THE MARYLAND-NATIONAL CAPITAL PARK AND PLANNING COMMISSION

MEMORANDUM

REVIEW TYPE: Site Plan Review
APPLYING FOR: C-1 Zone; 2.04 Acres Property
3,200 sf of Commercial Office
PROJECT NAME: Colesville Chevy Chase Bank
CASE #: 8-02032
REVIEW BASIS: Site Plan Review Required in the C-1 Zone, Article 59-C-341.2
Site Plan Review Required for commercial properties adjacent to
residentially zoned properties, Zoning Regulations 59-E-2.81

TYPICAL DIRECTIONAL ENTRANCE ONTO A DIVIDED HIGHWAY — CONSIDERATION FOR SINGLE UNIT TRUCKS

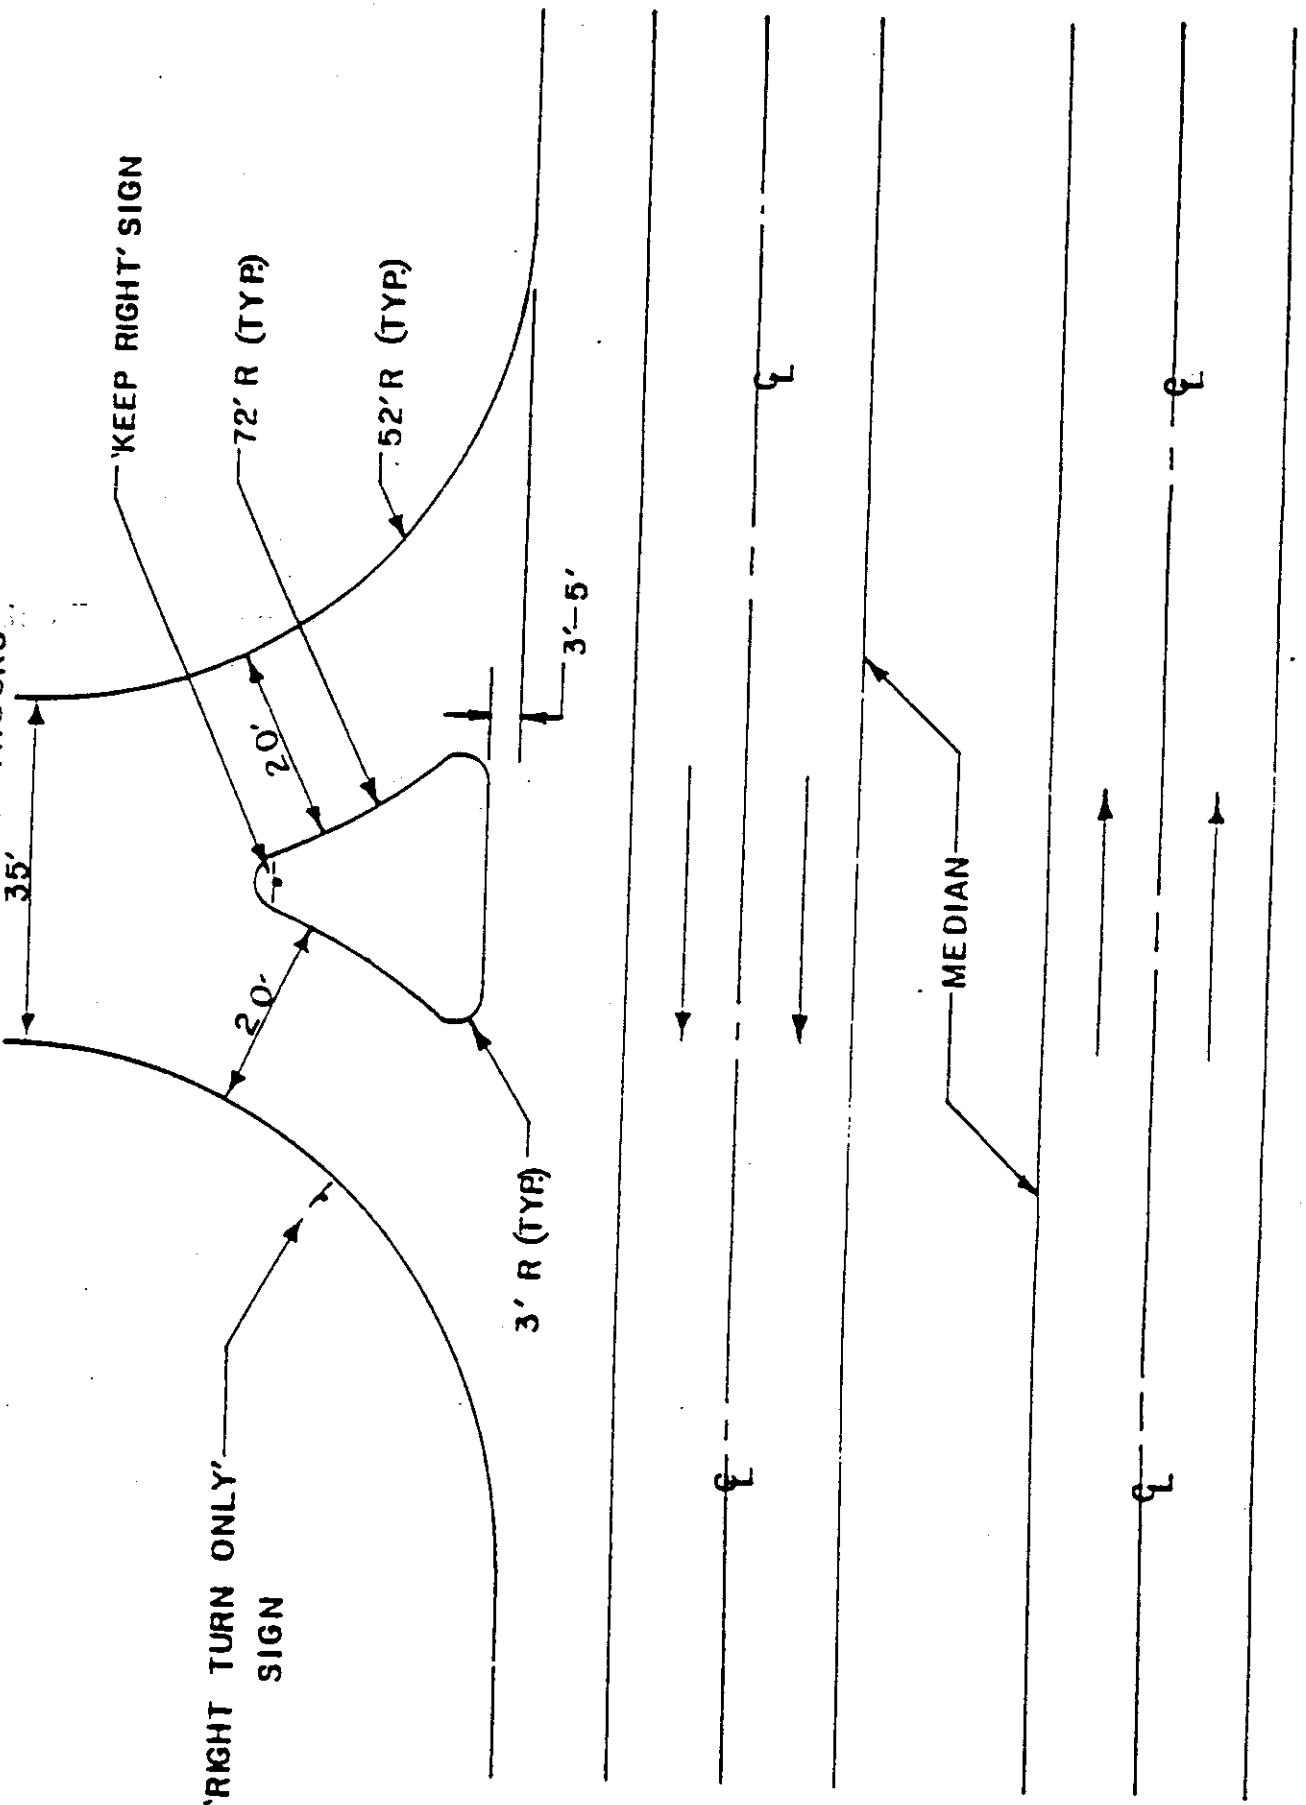
- Truncation and right-of-way dedication needs to be in accordance with the Master Plan of Highways.
- Access to this property is subject to the "Rules and Regulations" of this Administration with a permit issued by this office for entrance reconstruction and a storm drain connection.
- SHA will support (1) one typical directional entrance along MD 650. Please reference the attached standard.
- The term "denied access" is to be placed on the final record plat along the property that abuts MD 650, except at the approved entrance.
- Storm water drainage plans and computations are to be submitted for review.

- 4. Applicant to improve the entrance into the site from New Hampshire Avenue, consistent with MDSHA design standards and comments dated April 10, 2002. Applicant is limited to (1) one typical directional entrance along MD 650. [See attached memo dated April 10, 2002, Appendix B]
